COOPER NUCLEAR STATION

Amendment No. 22
License No. DPR-46

ATTACHMENT TO LICENSE AMENDMENT NO. 22

Request for: Cooper Nuclear Station Appendix B Technical Specification revisions to discontinue river sampling requirements at river miles 528 and 526.

FIGURE I. SAMPLING LOCATIONS IN THE VICINITY OF THE COOPER NUCLEAR STATION

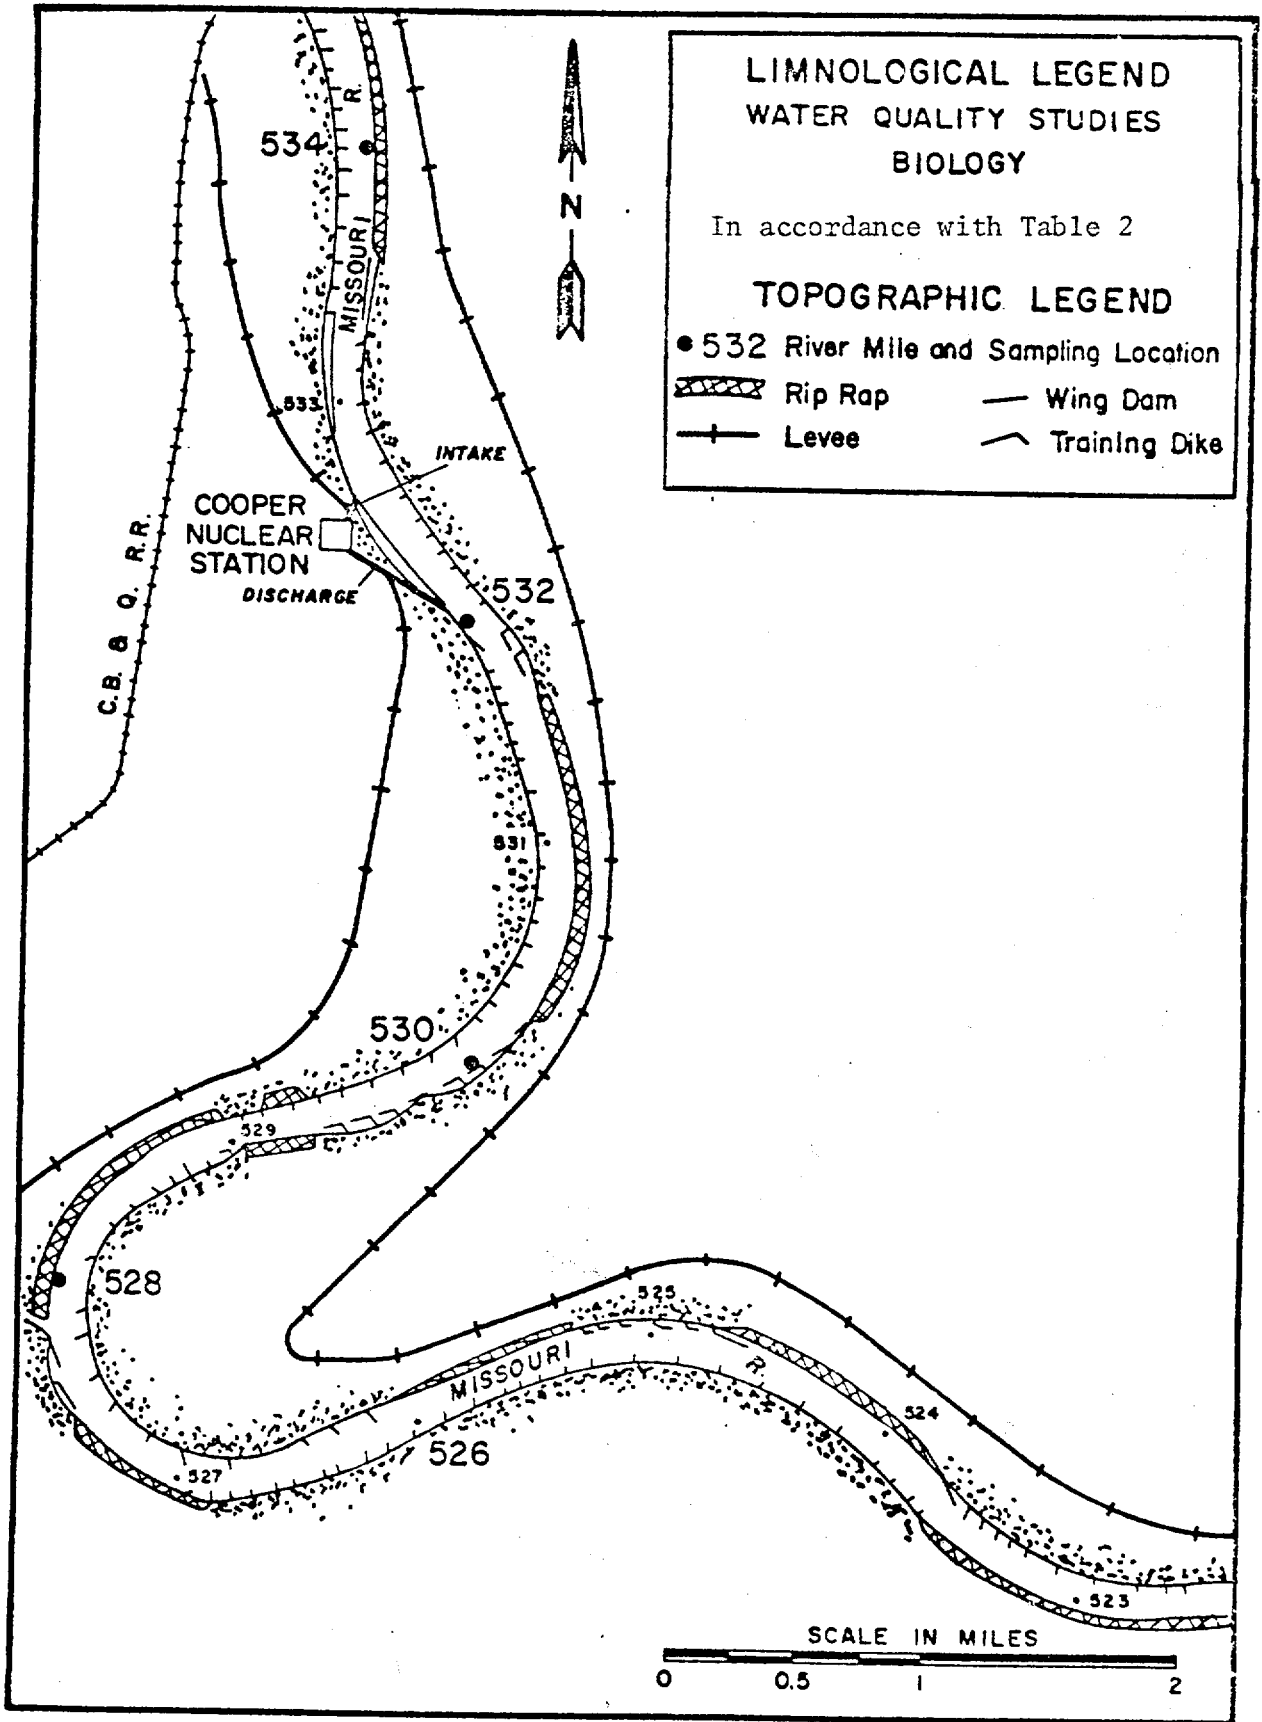
We have evaluated the potential for environmental impact of the operation in accordance with the enclosed amendment. Thermal plume surveys and biological studies have shown that river mile 526 lies downstream of the zone of moderate thermal influence. We have, therefore, concluded that the sampling station at river mile 526 may be eliminated. Although biological studies show no measurable thermal impact at river mile 528, river mile 528 may, at times, lie within the zone of moderate thermal influence. Therefore, possible long-term effects on certain aquatic biota at this location cannot be discounted. In excess of two to three years of analysis may be required to detect changes in aquatic macro-invertebrate and periphyton populations. Furthermore, elimination of laboratory chemistry samples at river mile 528 would remove the only source of data downstream of the Cooper Nuclear Station. On this basis, the amendment requires continued samples for Physical Measurements and Field Chemistry, Laboratory Chemistry, Aquatic Macroinvertebrates, and Periphyton at river mile 528.

This amendment revises the Environmental portion of the Technical Specifications for the facility to eliminate the monthly river sampling requirements at river mile 526, and certain unnecessary monthly river samples for May through November at river mile 528.

Duplicate water quality samples for laboratory analyses (Table 3) will be collected monthly (May-November) from four locations: RM534, in the immediate area of the intake, in the discharge canal and at RM528. Sampling will be restricted to the intake, discharge, and when possible RM 528 during the remainder of the year. Physical measurements (Table 4) and field analyses including dissolved oxygen, pH, total alkalinity, and turbidity will be performed at six locations: RM 534, intake, discharge, RM 532, RM 530, and RM 528. Field chemistry and nutrient analyses (Table 5) will also be performed at the appropriate locations as shown in Table 2.
